Access Compliance Report

Public Rights-of-Way (Curb Ramps)

Intersection ID: 19908	Main Street: BROWN-GRIER_RD	Cross Street: GALLANT_LN	Location: NW
ADA ID: 8B3339D0CAD0	Ramp Type: Directional1	Initial Pass/Fail: Fail	Overall Compliance: No
		Severity Score: 12.5

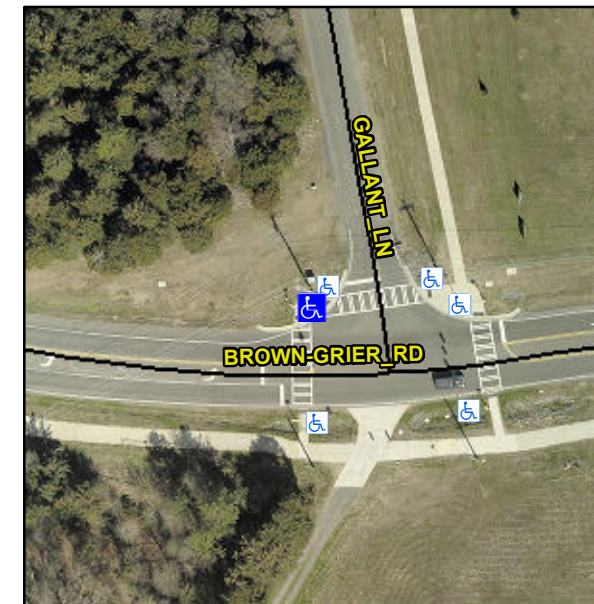
R304.5.3

Remove & Replace Entire Ramp.
